Addendum No.: 3

CT DAS | Construction Services | Office of Legal Affairs, Policy, and Procurement
Old Newgate Prison and Copper Mine Museum
Roof(s) Replacement and Exterior Renovations
115 Newgate Road
East Granby, CT
BI – RR – 30

ADDENDUM #3: CHIMNEY CAP
OLD NEWGATE PRISON & COPPER MINE
 ROOF REPLACEMENT AND EXTERIOR RENOVATIONS
 EAST GRANBY, CT
 Project No. BI-RR-30

1 CHIMNEY CAP
 SKA-01 1 1/2"=1'-0"

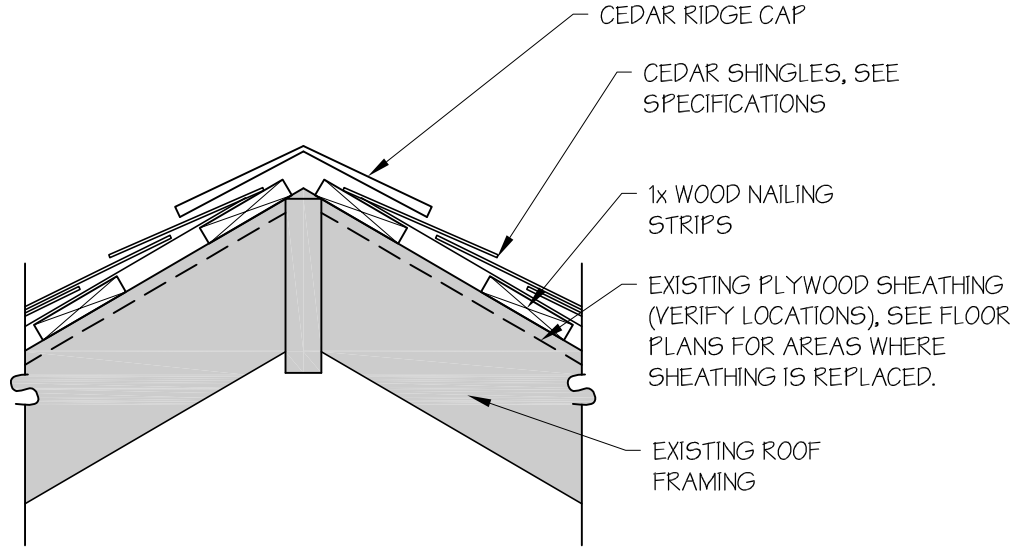
Q: Please provide detail for chimney caps that is to be installed by mason. Type & gage of metal/details for installation/edge detail/overhang?

A: Cap chimney with 22 gage galvanized metal chase cover (or fabricated cap with 22 gage x-bend galvanized metal with hemmed edges) over 3/4" marine grade plywood (use pressure treated blocking where needed to provide level surface) adhered with exterior grade silicone sealant. See SKA-01 dated 6/15/2018.
